**Medway Planning & Economic Development Board
Meeting**

Phytopia Public Hearing Continuation
Major Site Plan, Reduced Parking
Special Permit and Groundwater
Protection Special Permit

**Re: Phytopia Inc.
 Major Site Plan Review
 6 Industrial Park Road
 Medway, Massachusetts**

SHEET 10 OF 14

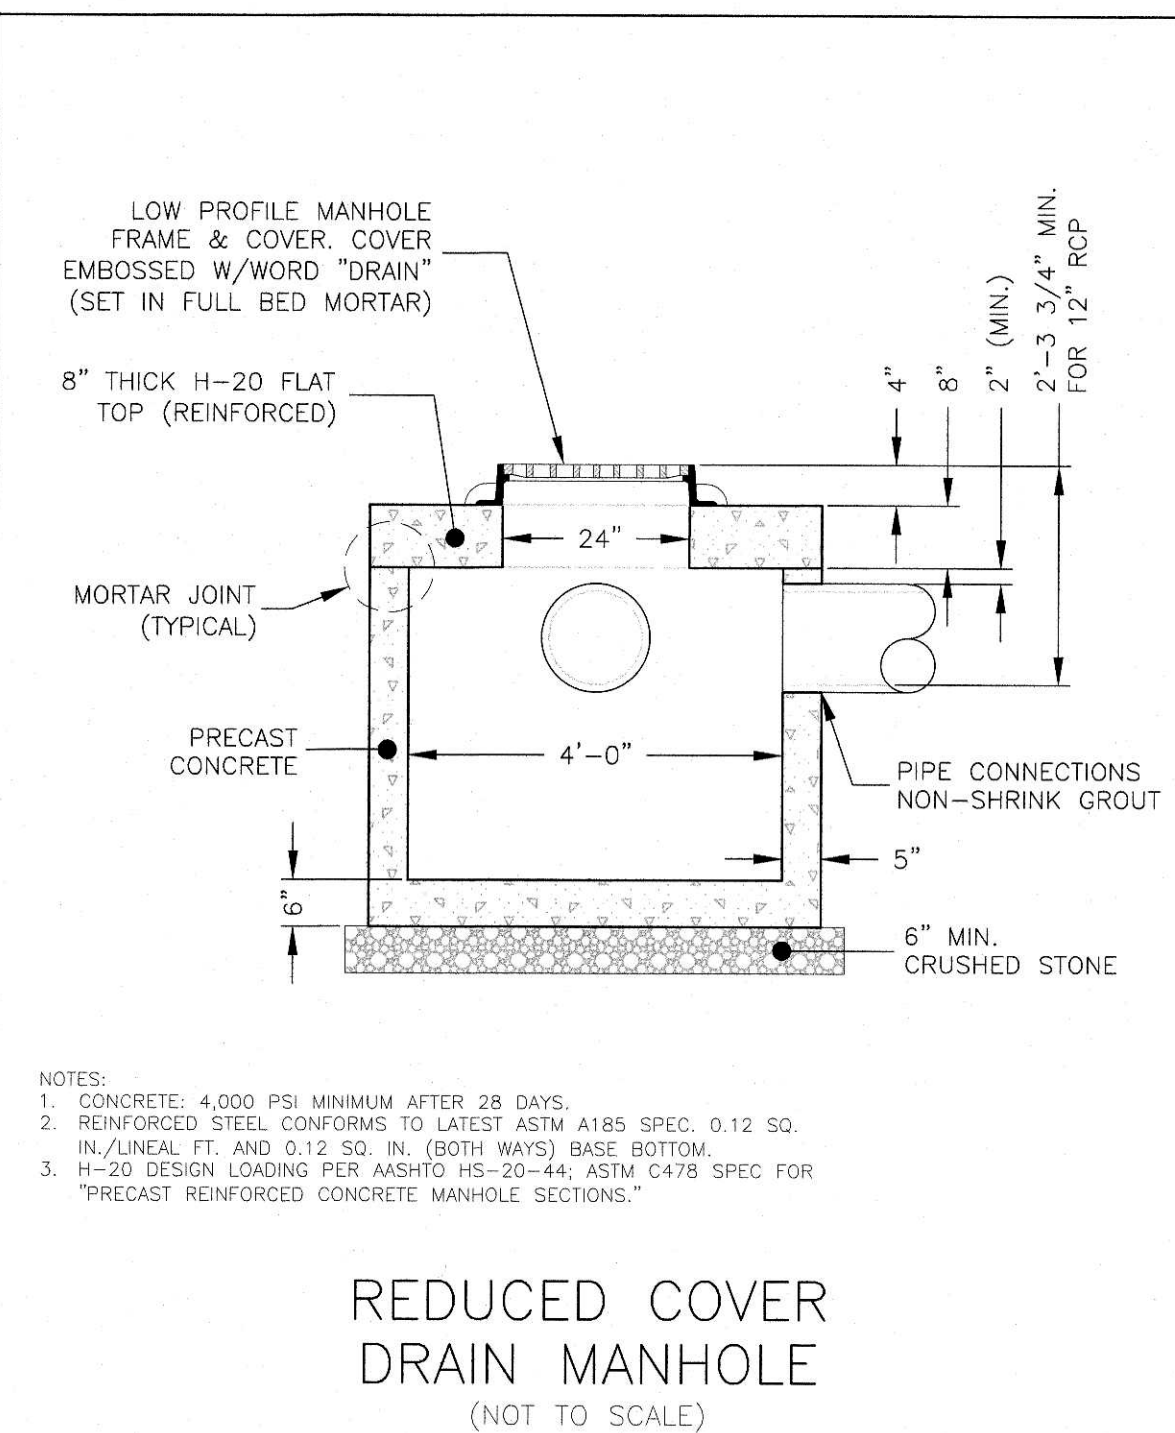
37. Mulch sock should be depicted in the "Siltfence with Mulch Sock" detail on the Construction Details Plan.
- *WSE 10/12/21 Response: Mulch sock is depicted on the Construction Details Plan, see sheet 9.*

- **TT 10/27/21 Update: The detail does not appear to be correct as certain information is missing on the detail or is not showing up correctly when printed from CAD.**

- *WSE 4/12/22 Response: The detail has been corrected. See sheet 10 of the plan set.*
 - **TT 4/22/22 Update: In our opinion, this comment is resolved.**
